MINUTES OF THE PUEBLO CONSERVANCY DISTRICT SPECIAL MEETING ON JANUARY 19, 1987

The purpose of the meeting was to have a special report from the Engineers on the progress and problems of a leak in the grade control structure construction on Santa Fe.

January 19, 1987

This letter summarizes the activities, measurements and analyses we have performed on the Santa Fe Avenue Dam during past few weeks.

FIGURE 1
PIEZOMETER LOCATION
DRAWING

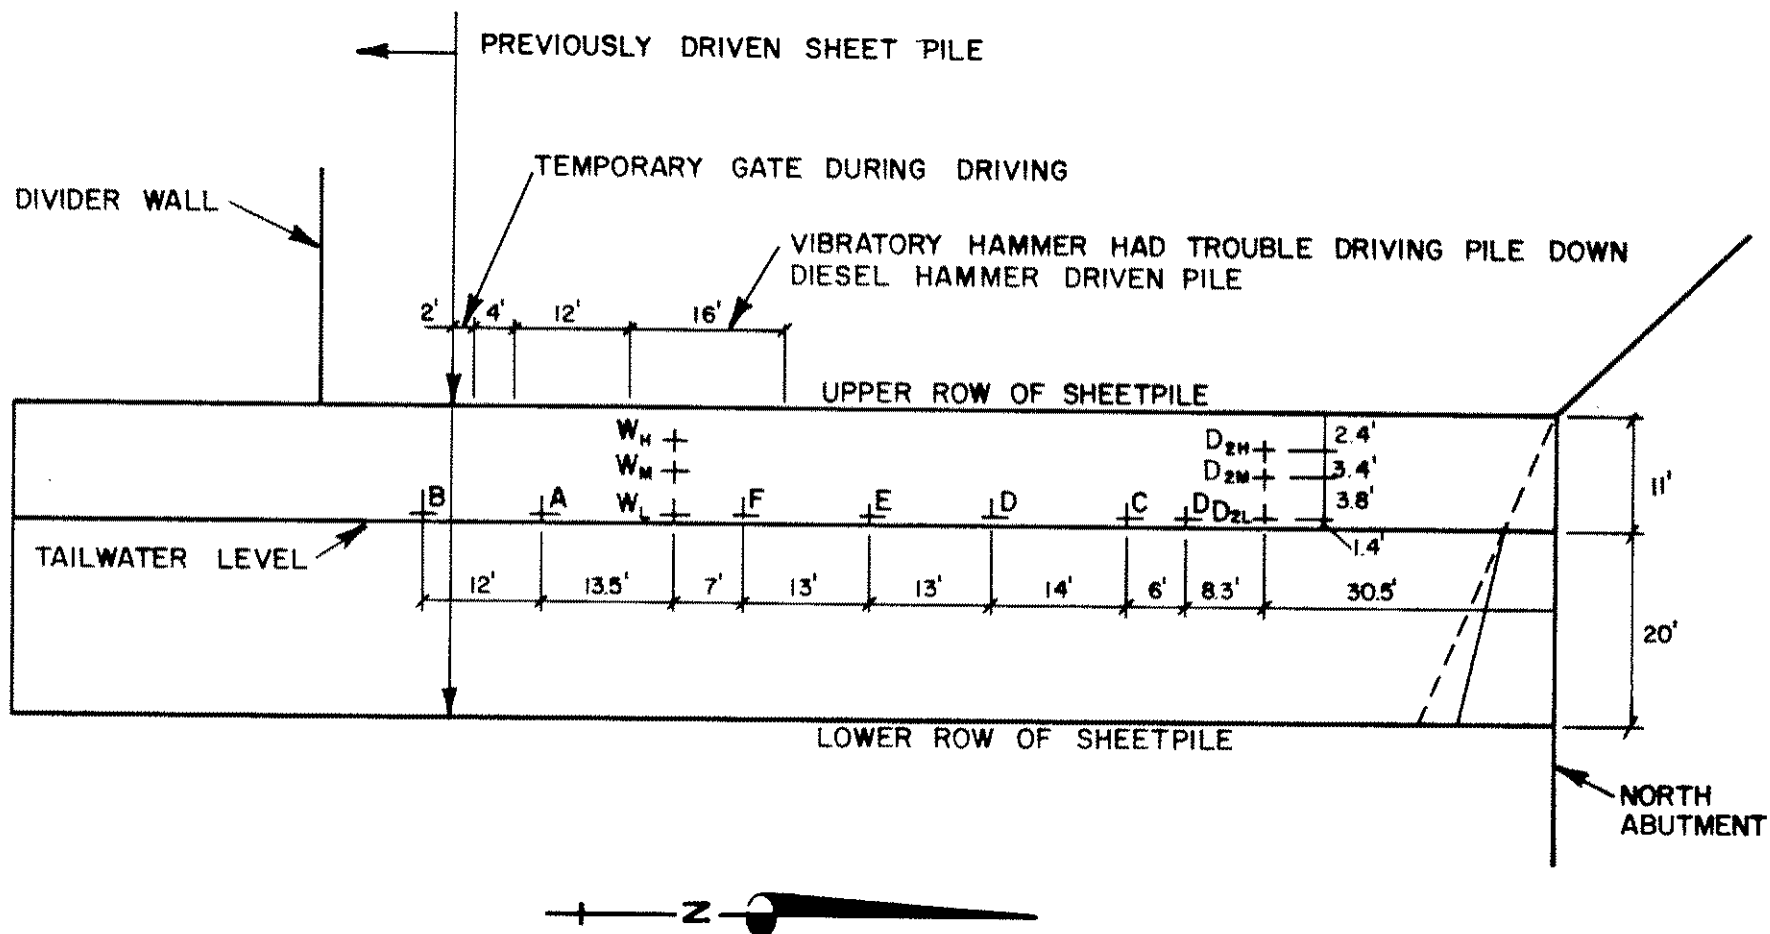
AT ABOUT 12:30PM THE CONTRACTOR DRILLED 3 HOLES (W₁, D₁, D_{2L} ON FIG 1) IN THE DAM FACE. THE WATER RAISED TO ELEVATION 50³¹ IN TEST HOLE W₁ AND IN TEST HOLE D₁ AND D_{2L} IT WAS 6" BELOW THE GROUT SURFACE. THE CONTRACTOR DRILLED THE THIRD TEST HOLE BECAUSE HE THOUGHT THAT HE HAD HIT A TIE BEAM WITH THE SECOND HOLE.

FIGURE 2
CROSS SECTION
TEST HOLES W

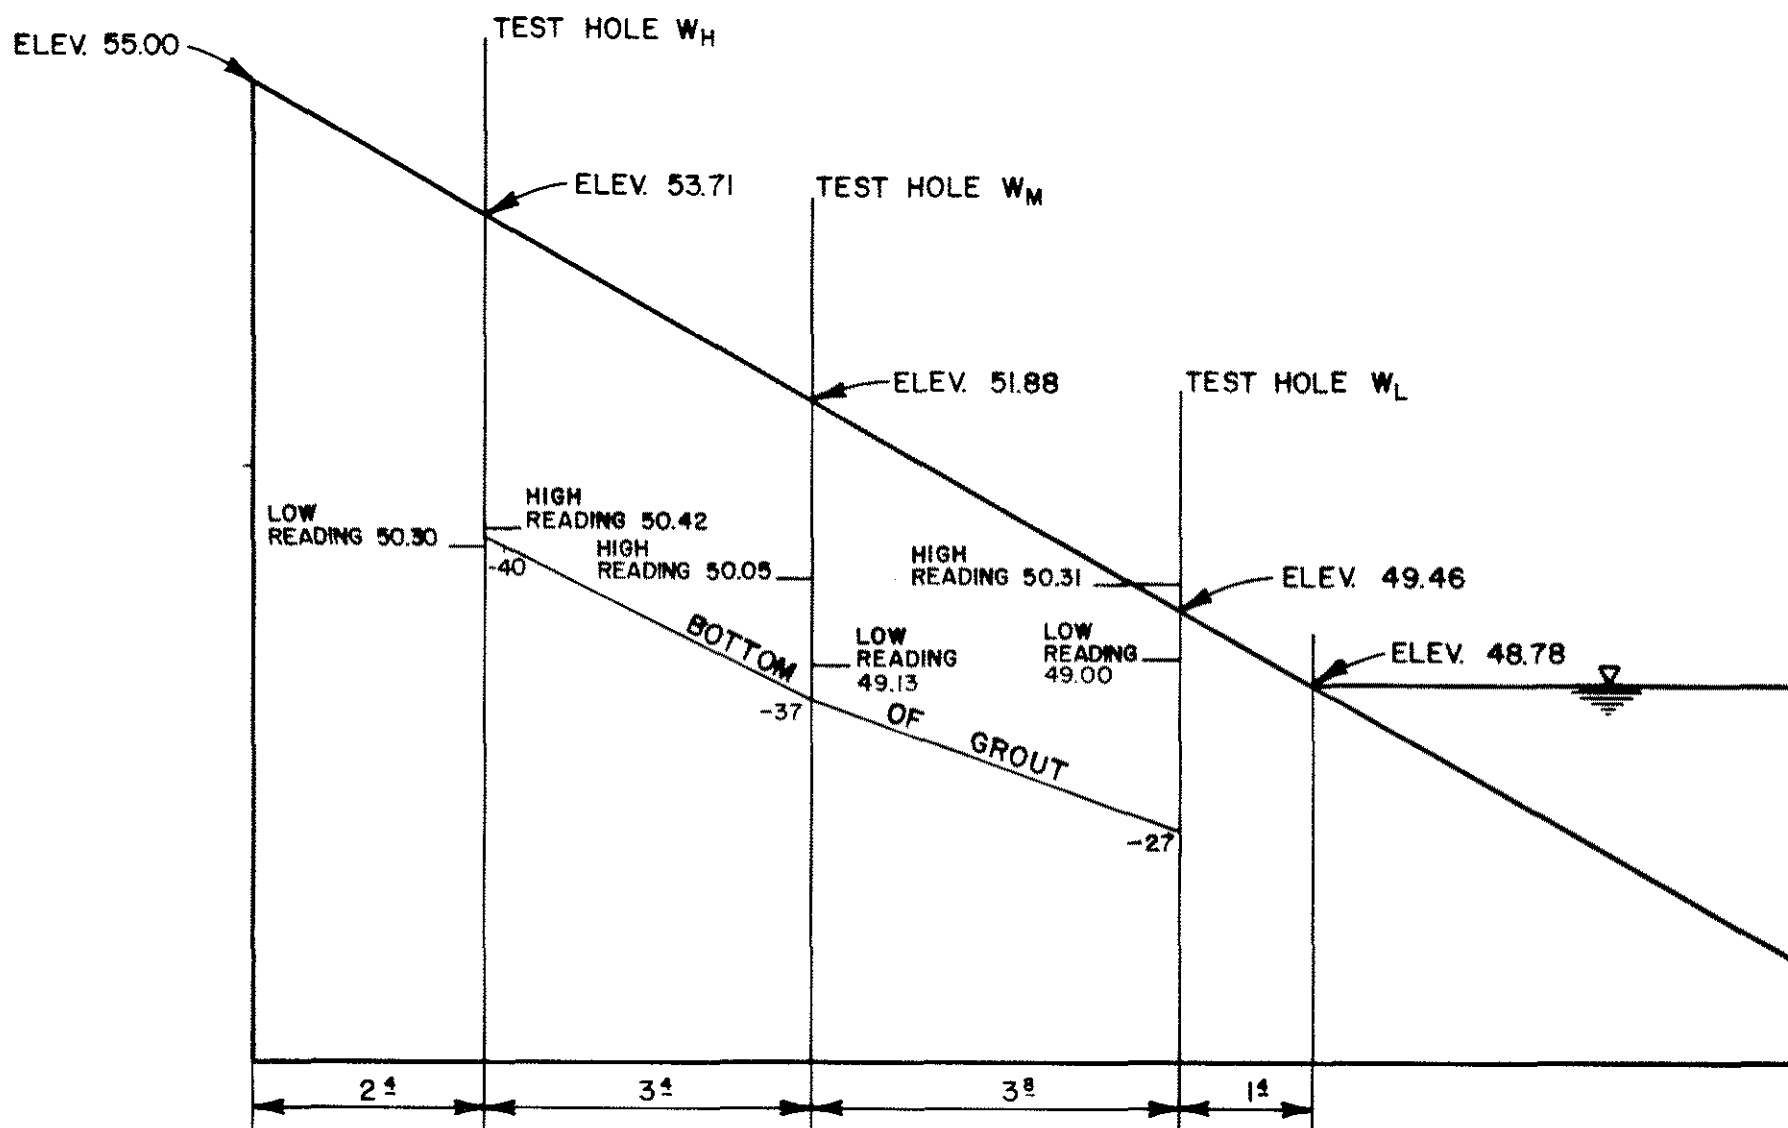
The construction records were reviewed and it was observed that sheet pile driving encountered problems in the area where the piezometric head was found higher and where the leak was occurring. In order to investigate the cause of the problem in further detail, we directed installation of piezometers along sections perpendicular to the longitudinal axis of the dam. The locations of all the piezometers installed are shown in Figure 1. The piezometer readings are summarized in Table 1. The piezometer readings were plotted along each section perpendicular to the axis of the dam and parallel to the dam axis. They are shown in Figures 2 through 4.

As can be seen from the piezometer readings, the readings have consistently gone down in all locations, eventhough the upstream water surface has varied from elevation 53.03 to elevation 55.00 (top of dam).

FIGURE 4
LATERAL INTERPRETATION
OF PIEZOMETER DATA

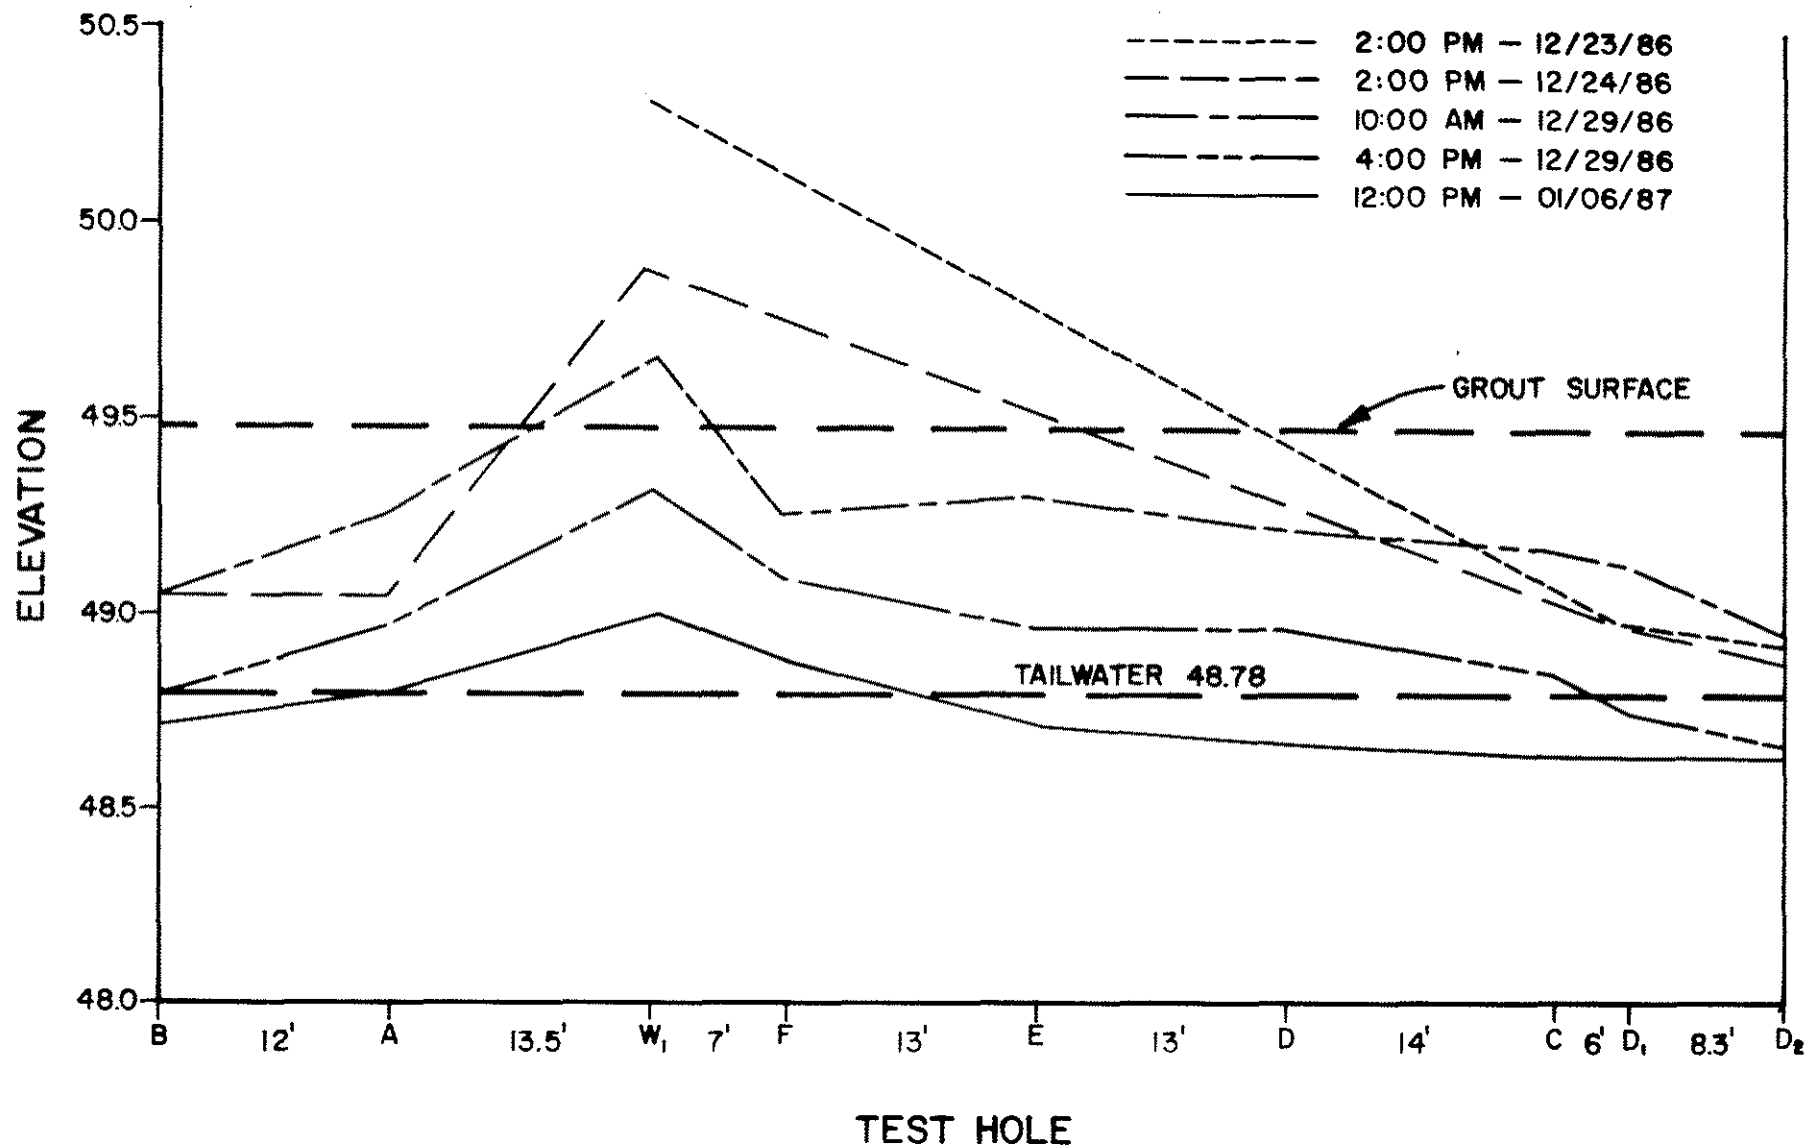
However, the readings have remained relatively high in the observed problem area as illustrated in Figure 4.

The consistent high piezometer readings at the trouble spot indicate that the opening through or under the upstream row of sheet piles is probably more than in the other areas of the dam. The excess flow here apparently travels laterally under the dam and discharges at the many weepholes on the downstream face. This explains the gradient away from the trouble area and could possibly indicate reduced capacity thru the weeps on the downstream row of sheet pile.

However, due to the coincidence of high piezometer readings in the area, where problems were encountered in driving the sheet piles (use of diesel hammer instead of vibratory hammer), the data implies the possibility that sheet piles might have buckled, a joint partially separated, a hole was cut (we are not aware of any), and/or the pile did not penetrate to bedrock in that area. There is always the possibility of boulders or cobbles obstructing the penetration of the sheet piles.

Figure 14

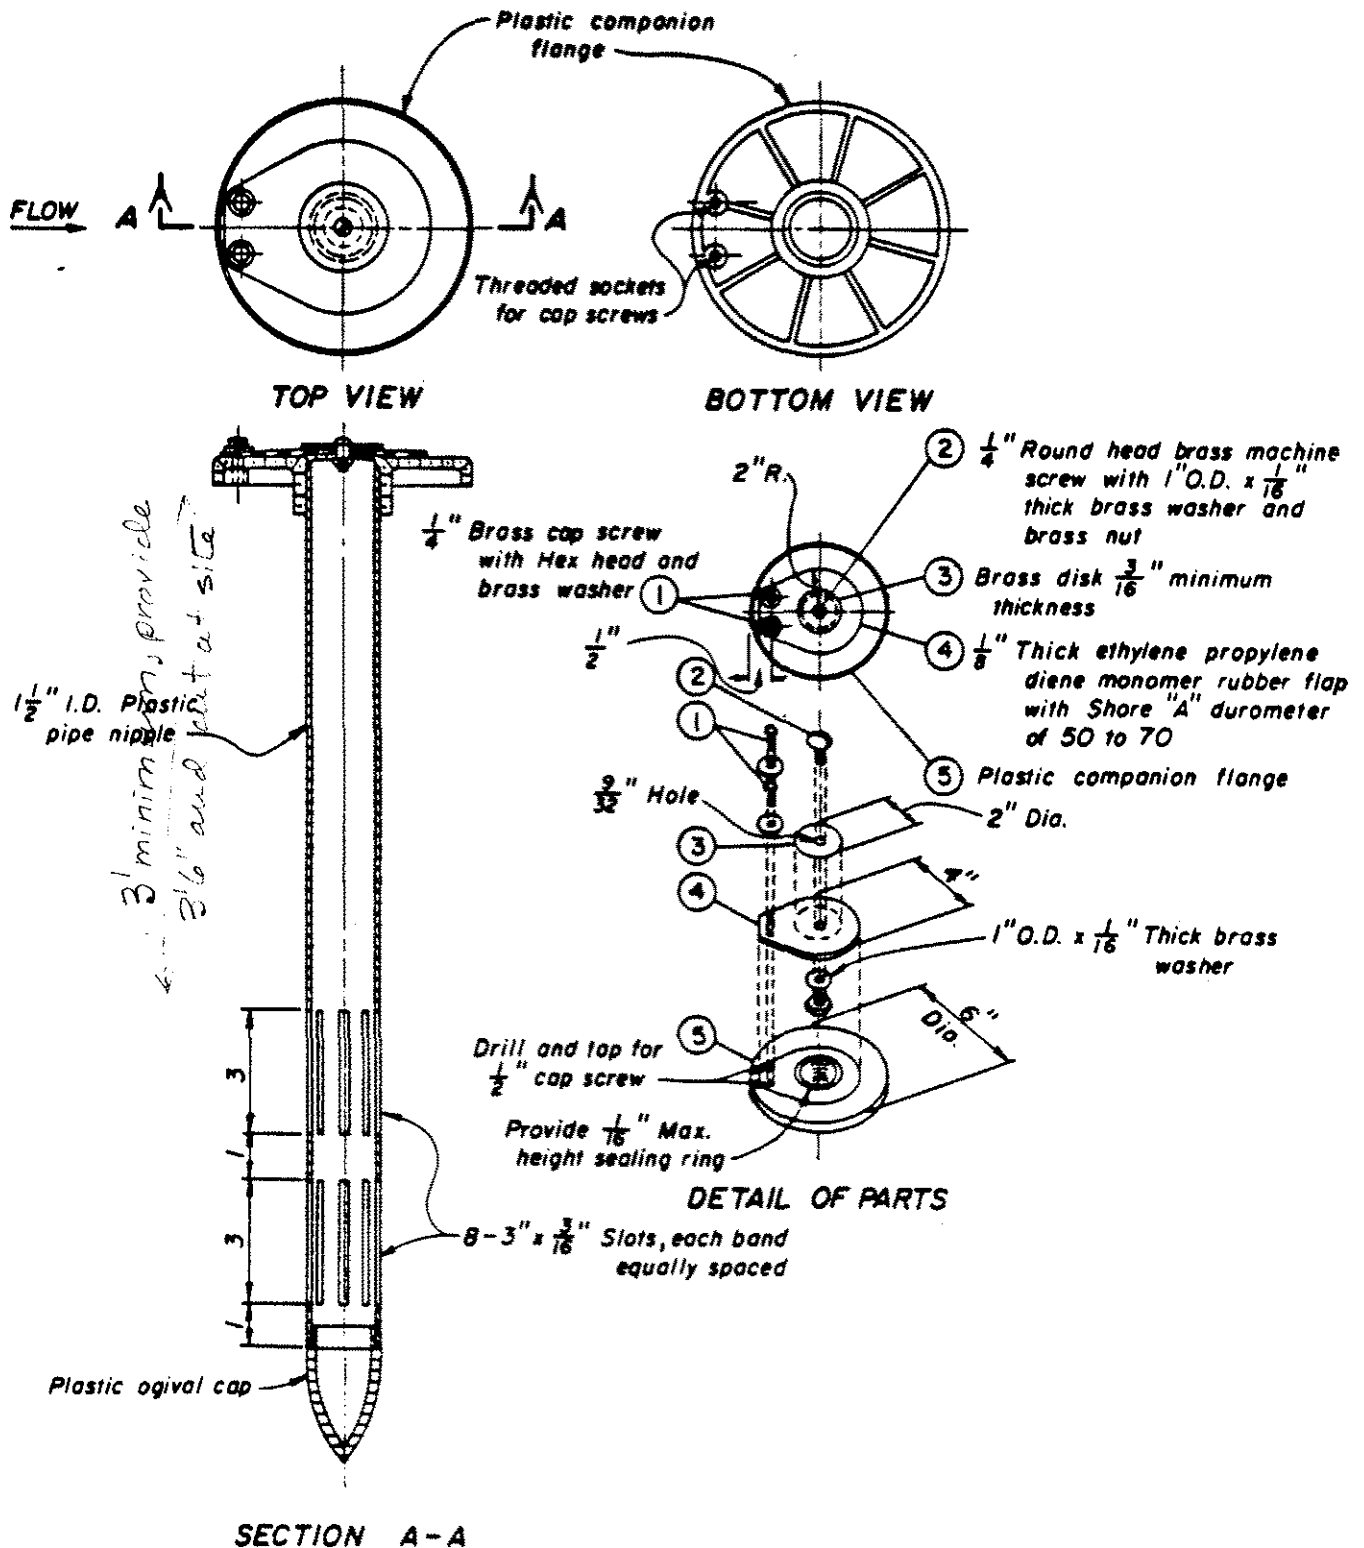
Pressure relief is the recommended minimum option. Several options were explored, but the Bureau of Reclamation has a flap weep valve which they use for relief of pressure under linings. We visited several people at the Bureau, reviewed several technical papers, and interviewed the likely manufacturer. A copy of their diagram is attached. These should adequately relieve the pressure. They will need to be installed at intervals horizontally (to relieve inflow all along the dam) and vertically because the desired relief location varies with different tailwater and nappe locations. The flap is necessary to prevent the introduction of flow into the subgrade for lower flow levels (the water could enter a given weep on the top of the dam and then could pressurize the subgrade). Maintenance would be required, but the Bureau's experience has been minimal. We would expect more maintenance because of the potential for vandalism and the rugged location.

The construction is simple, requiring drilling of a hole, placing the drain, gluing the cover flange and grouting in place. The manufacturer quoted \$22 per unit and suggests an installation cost of \$5 to \$20 per unit. The thicker grout layer and difficulty in getting the drain to go into the subgrade soil makes us think costs could be higher (on the order of 75 to \$100 apiece). Generally we recommend installation of two rows at five foot spacing at elevation 52 (plus or minus one foot) and elevation 50 (plus or minus one foot). They should be installed downstream of the larger rock where there is better protection. This would require 48 units or a budget of \$3,600 to \$4,800. These drains would both help to rectify the problem area and generally be an improvement of the dam.
